SERVICE BULLETIN

ENGINE — NO. 4 BEARING SCAVENGE TUBE ASSEMBLY — REPLACEMENT
OF, WITH A HIGHER STRENGTH TUBE

V2500 Series 72-0650

V2500-ENG-72-0650

LOCATION OF THE NO. 4 BEARING SCAVENGE TUBE ASSEMBLY
72-42-20
FIGURE 1

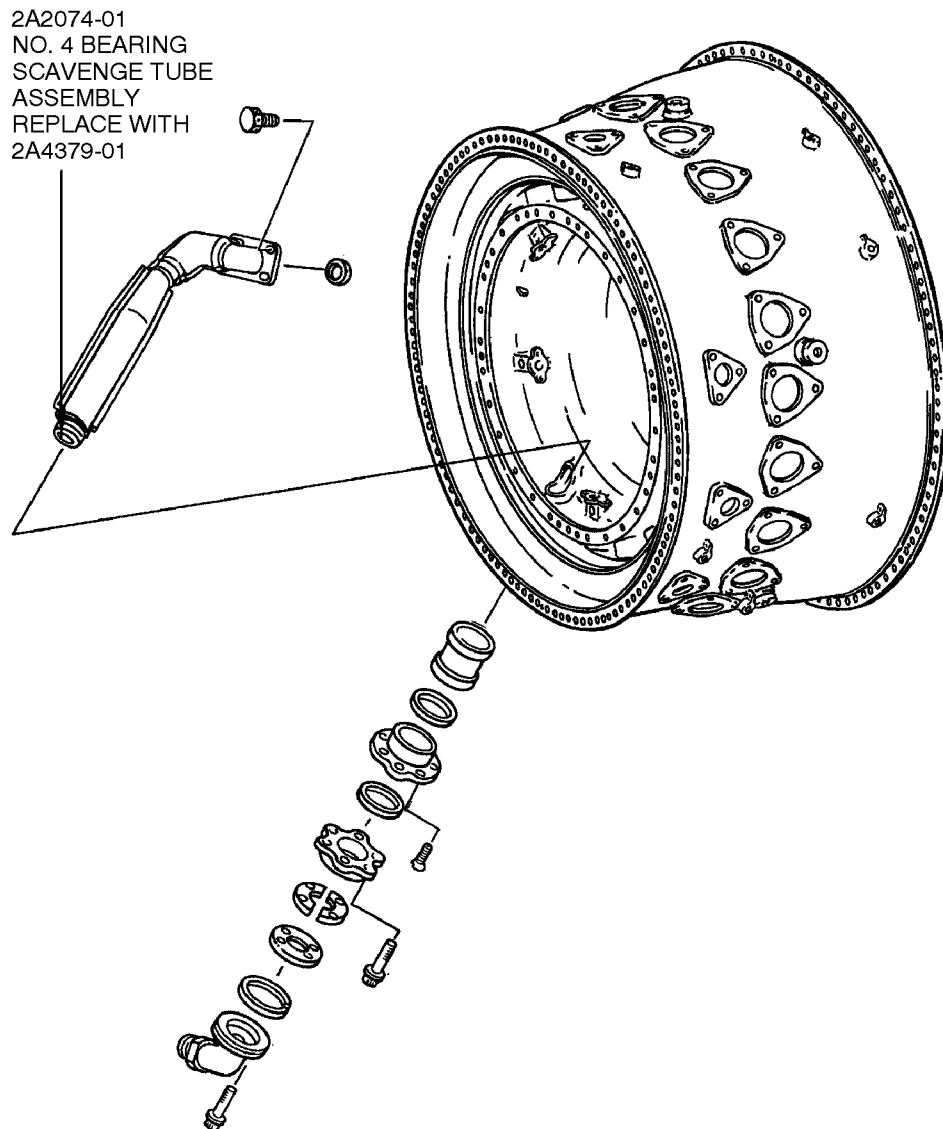
1. Remove No. 4 Bearing Scavenge Tube Assembly, PN 2A2074-01 in accordance with Reference 5 or 6, V2500 A1/A5 Series Engine Manual, P&W Ref. PN 2A4407 or V2500-D5 Series Engine Manual, P&W Ref. PN 2A4416, Chapter/Section 72-42-00-040-001. See Figure 1.
2. Install No. 4 Bearing Scavenge Tube Assembly, PN 2A4379-01 in accordance with Reference 5 or 6, V2500 A1/A5 Series Engine Manual, P&W Ref. PN 2A4407 or V2500-D5 Series Engine Manual, P&W Ref. PN 2A4416, Chapter/Section 72-42-00-430-001. See Figure 1.
3. Recording Instructions
 - A. A record of accomplishment is required.

NO. 4 BEARING SCAVENGE TUBE ASSEMBLY CHART A

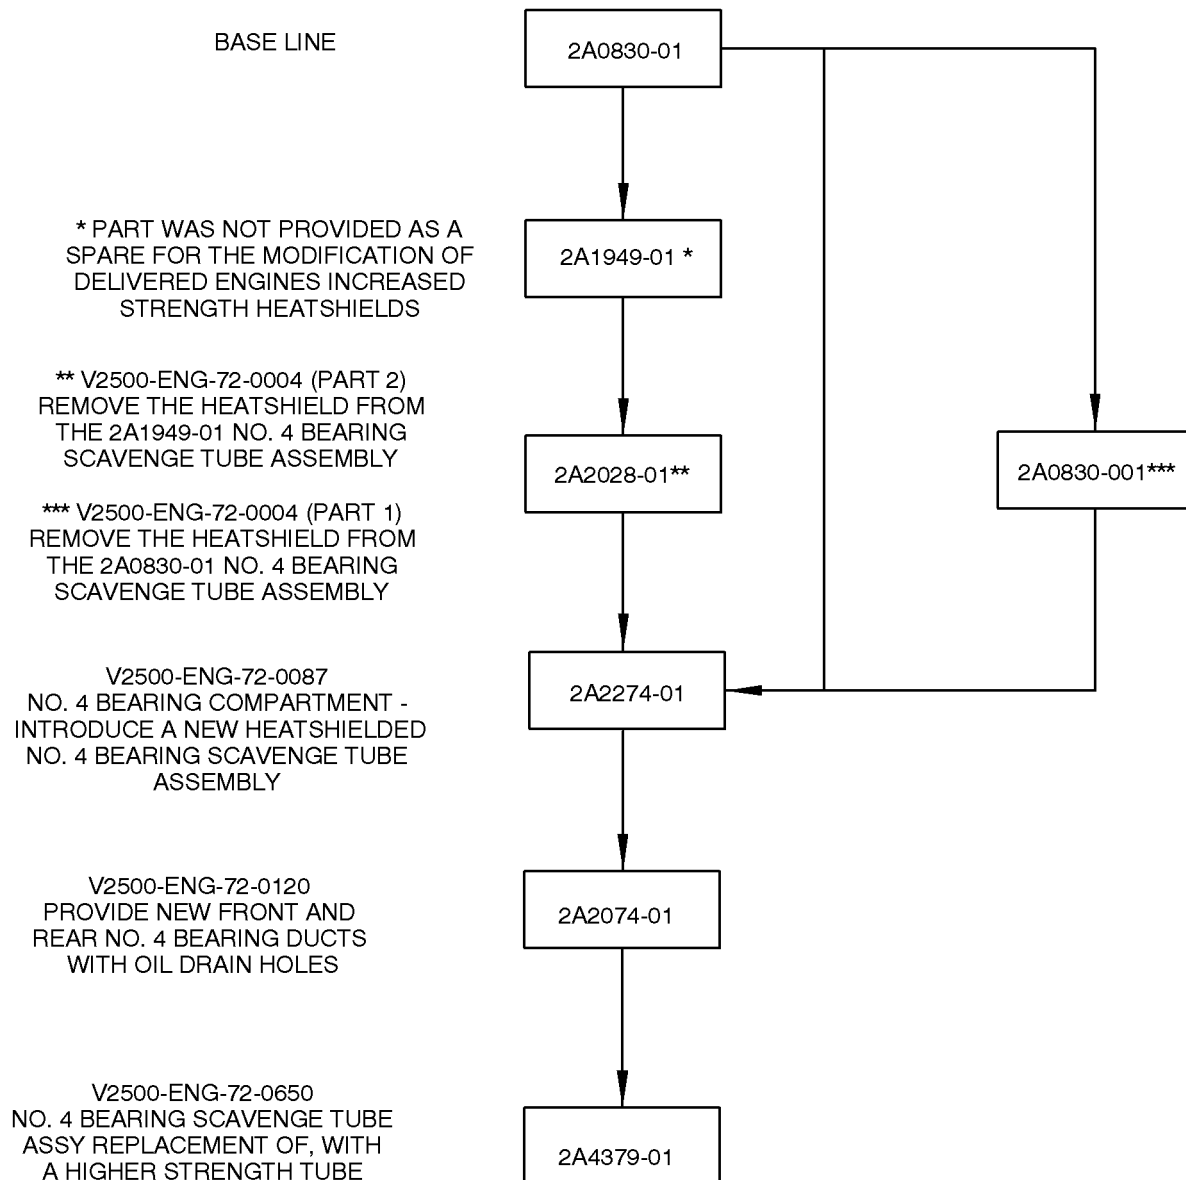
Parts Progression To Show the Changed Part in Relation to Other Parts
